## CONDITIONAL USE PERMIT APPLICATION

NOBLE KNIGHTS  
CITY OF FITCHBURG  
SITE PLAN

Application: CS-2171-17 & CU-2172-17  
Property Location: Commerce Park Drive  
Review Date: September 20, 2017  
*Planning Staff Review #1*

DATE: 10/1/17  
DESIGNED:  
DRAFTED:  
PROJECT #:  
SHEET:  
C-1.0

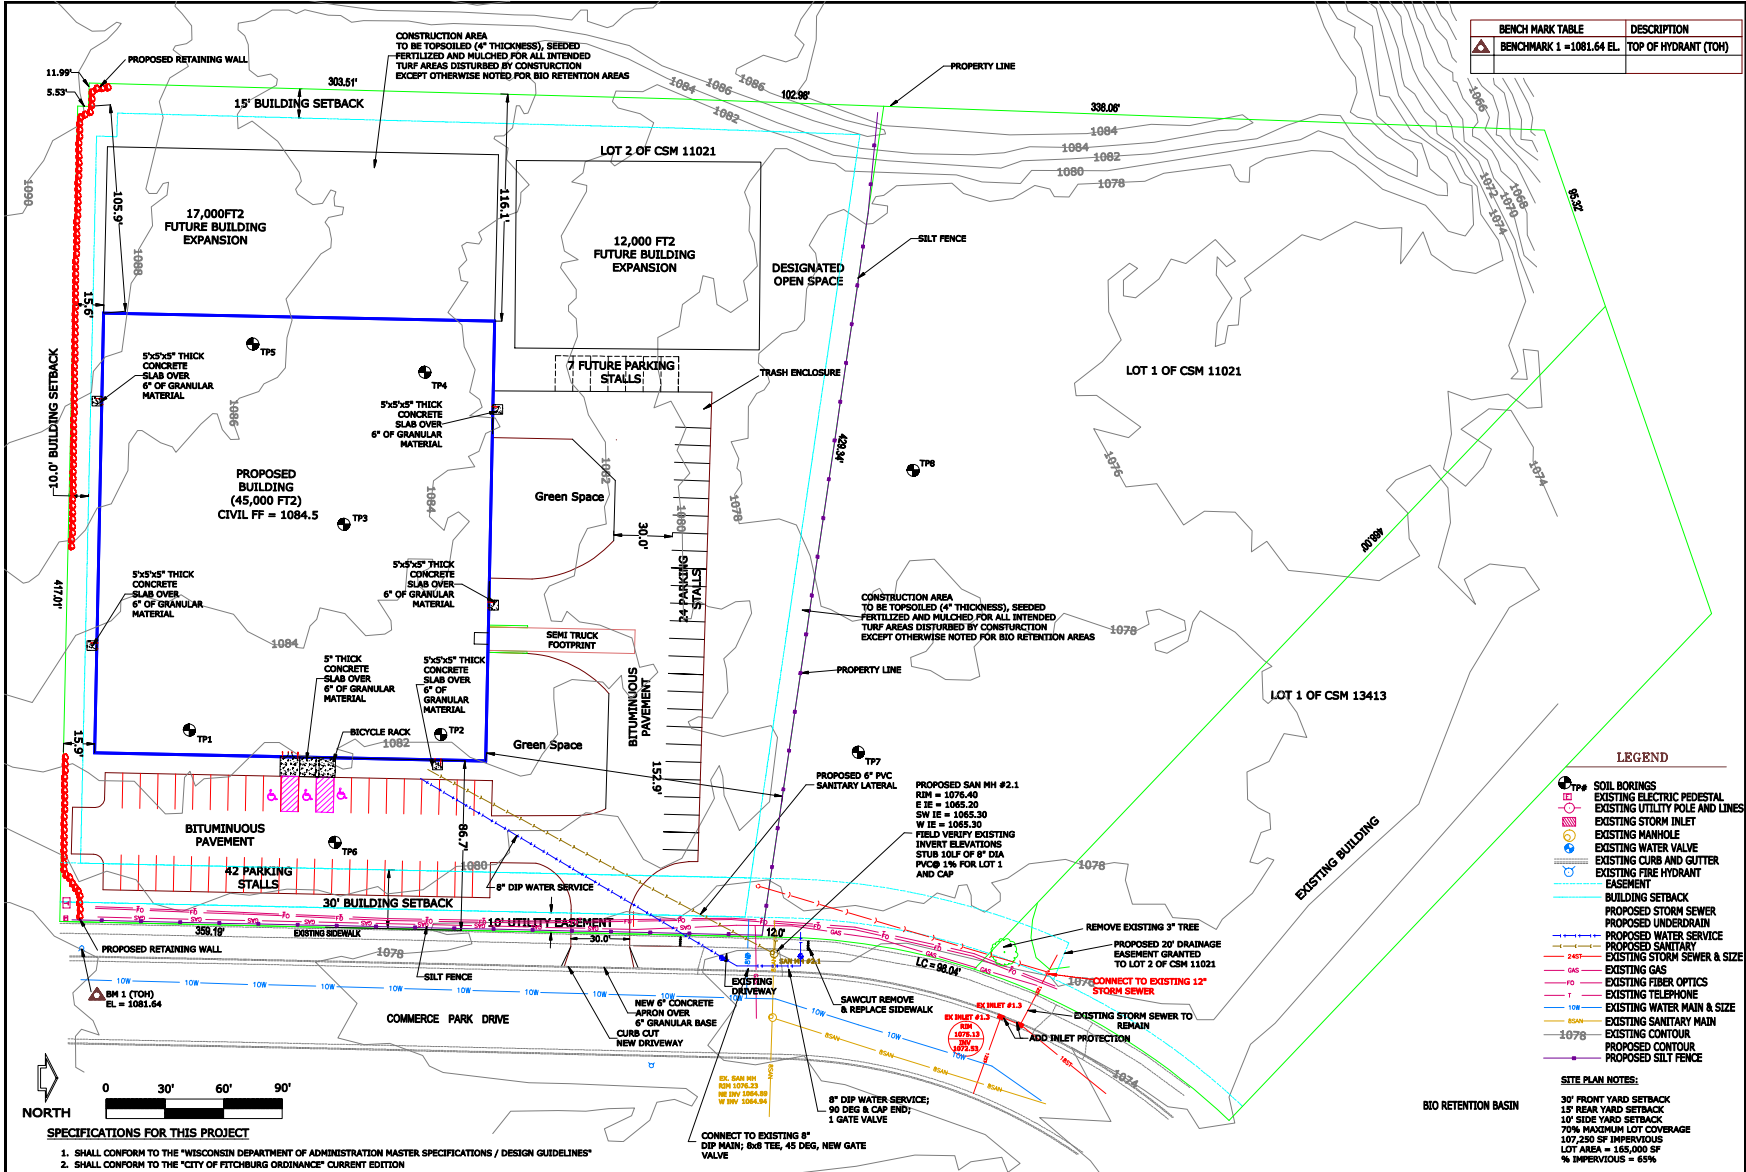
4. What is the anticipated maximum capacity of the building with customers? The absolute maximum of the building would be 300 people.
5. What is the purpose of the line to the north of the building? This line is showing the required rear yard setback lines and that the proposed expansion is not over the setback line.

6. Please dimension building to each of the nearest property lines. Need this information. Attached is an updated site plan which shows all of the setbacks.

7. I counted 25 stalls at the north end; the site plan shows 24 parking stalls. Please confirm and update plan as necessary. 24 stalls is correct. The open space at the west most end is not a parking stall. This is marked more clearly on the latest site plan which is attached.

11. Are two handicap stalls sufficient for the number of parking stalls provided? There are 3 handicap stalls on the latest plan and we believe this is sufficient.

12. What is proposed impervious surface ratio? For the initial 45,000 square foot building the impervious surface ration is 47%. For the proposed expansions we will not exceed 70% impervious surface ratio based on the published code.
